ELECTRONICS FIELD CHANGE BULLETIN

2-AN/PDR-27CY

REPLACES POWER SUPPLY SECTION

**PURPOSE:** To replace present power supply section and batteries with a standard BATTERY POWER SUPPLY, PP-4814/PDR-27C, and standard size "D" batteries, mil type BA-30. (NOT SUPPLIED.)

AN/PDR-27CY ; WIRING DIAGRAM

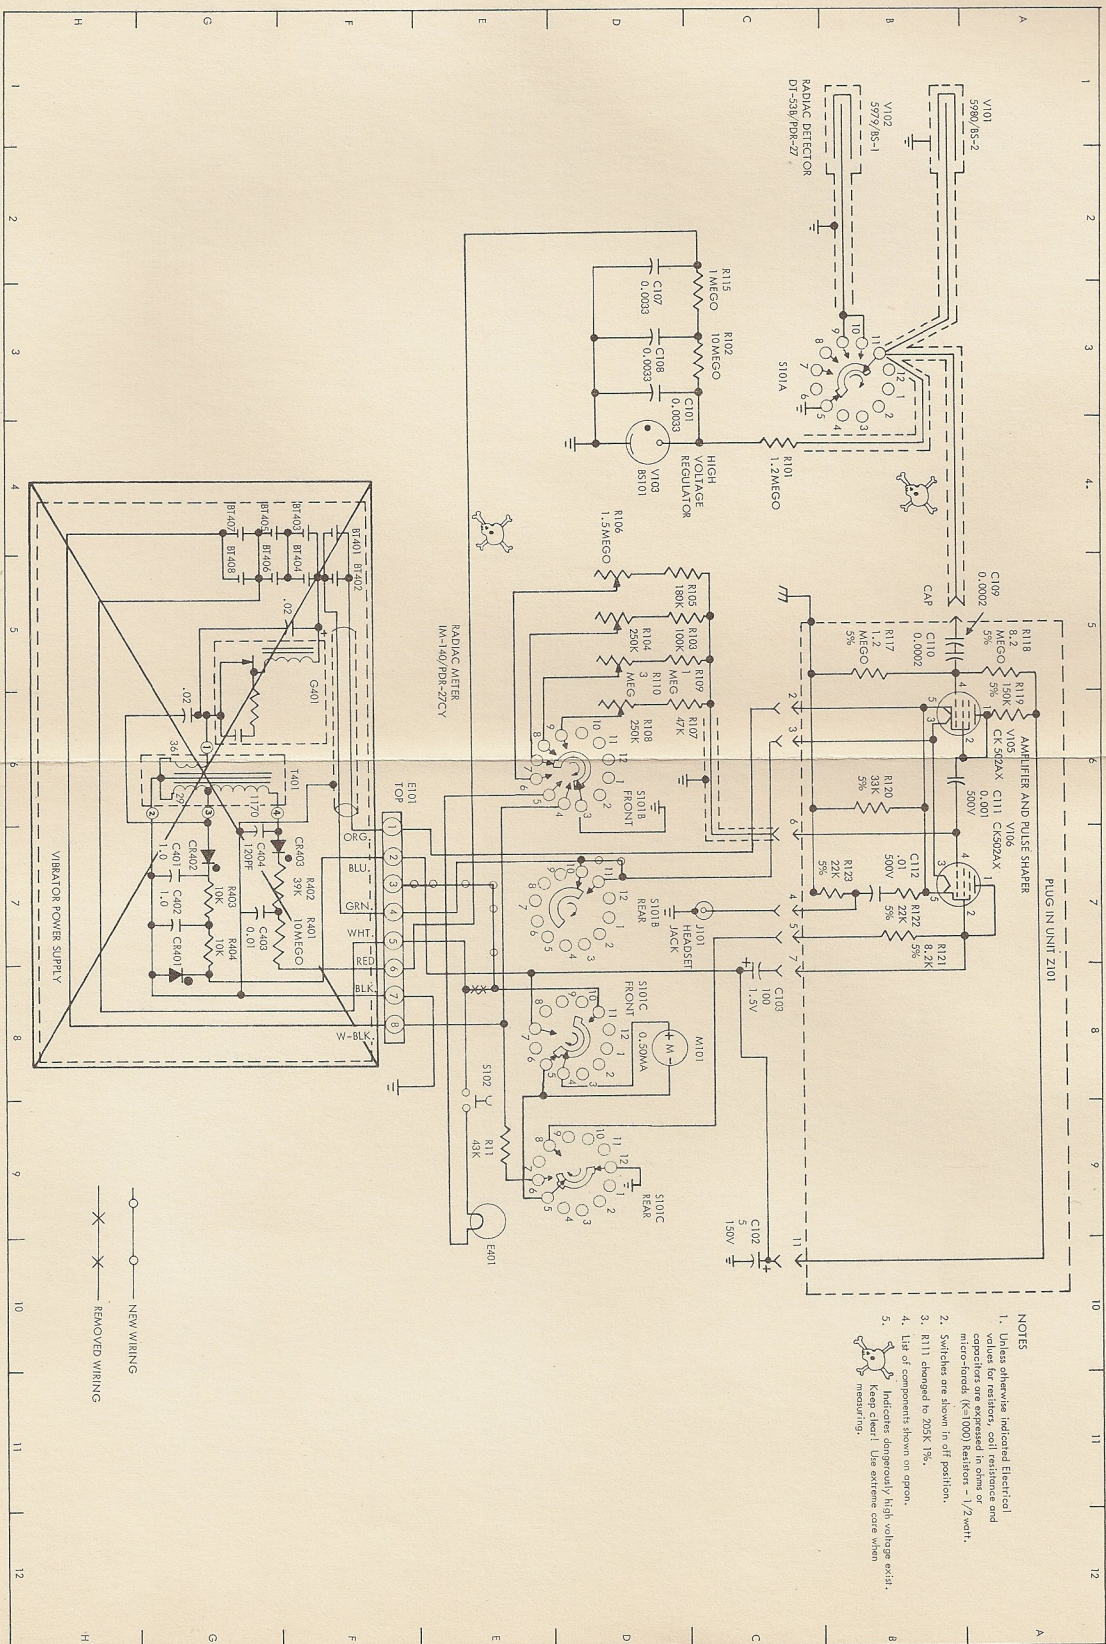
WIRE	COLOR	FROM	TO	REMARKS
1	BLK-YEL	E101-4	S101B-R10	Move to E101-1
2	ORG	E101-1	XZ101-2	Move to E101-2
3	BLK-WHT	E101-8	S101B-F4	Move to E101-3
4	WHT	E101-3	S101C-F11	Move to E101-4
5	BLU	E101-2	C103	Move to E101-5
6	WHT	E101-5	S102	Move to E101-6
7	RED	E101-6	C107	Move to E101-7
8	BLK	E101-7	XZ102-GRD	Move to E101-8
9	RED	S101A-F3	R102	Heavy wire
10	--	-	-	Not used
11	BLK	S101A-F5	S101B-F3	Ground bus
12	--	-	-	Not used
13	YEL	S101A-F7-8	V101-P	Heavy wire
14	BUS	S101A-F7-8	S101A-F11	Bus
15	SHIELD	S101A-F9-10	V102-P	Shield
16	SHIELD	S101A-F11	Z101-CAP	Shield
17	BLK	S101B-F3	S101C-R12	Ground bus w/sleeving
18	BLK	S101C-R12	L101-G	Ground bus
19	WHT	S101B-F5	E401	-
20	WHT-RED	S101B-F6	R106	-
21	WHT	S101B-F7	R104	-
22	WHT-YEL	S101B-F8	R110	-
23	WHT-ORG	S101B-F9	R108	-
24	WHT-BLK	S101B-R11	XZ101-3	-
25	--	-	-	Not used
26	RED	S101C-F4	M101(+)	Heavy wire
27	BUS	S101C-F5	S101C-R5	Bus
28	BLK	S101C-F5	M101(-)	Heavy wire
29	YEL	S101C-F7	XZ101-11	-

WIRE	COLOR	FROM	TO	REMARKS
1	BLK-YEL	E101-1	S101B-R10	Moved from E101-4
2	ORG	E101-2	XZ101-2	Moved from E101-1
3	BLK-WHT	E101-3	S101B-F4	Moved from E101-8
4	WHT	E101-4	S101C-F11	Moved from E101-3
5	BLU	E101-5	C103	Moved from E101-2
6	WHT	E101-6	S102	Moved from E101-5
7	RED	E101-7	C107	Moved from E101-6
8	BLK	E101-8	Z102-GRD	Moved from E101-7
9	RED	S101A-F3	R102	Heavy Wire
10	--	-	-	Not Used
11	BLK	S101A-F5	S101B-F3	Ground Bus
12	--	-	-	Not Used
13	YEL	S101A-F7-8	V101-P	Heavy Wire
14	BUS	S101A-F7-8	S101A-F11	Bus
15	SHIELD	S101A-F9-10	V102-P	Shield
16	SHIELD	S101A-F11	Z101-CAP	Shield
17	BLK	S101B-F3	S101C-R12	Ground Bus w/sleeving
18	BLK	S101C-R12	(L101-G)	Ground Bus; tie point only
19	WHT	S101B-F5	E401	-
20	WHT-RED	S101B-F6	R106	-
21	WHT	S101B-F7	R104	-
22	WHT-YEL	S101B-F8	R110	-
23	WHT-ORG	S101B-F9	R108	-
24	WHT-BLK	S101B-R11	XZ101-3	-
25	BUS	S101B-R10	S101B-R11	New Wire
26	RED	S101C-F4	M101(+)	Heavy Wire
27	BUS	S101C-F5	S101C-R5	Bus
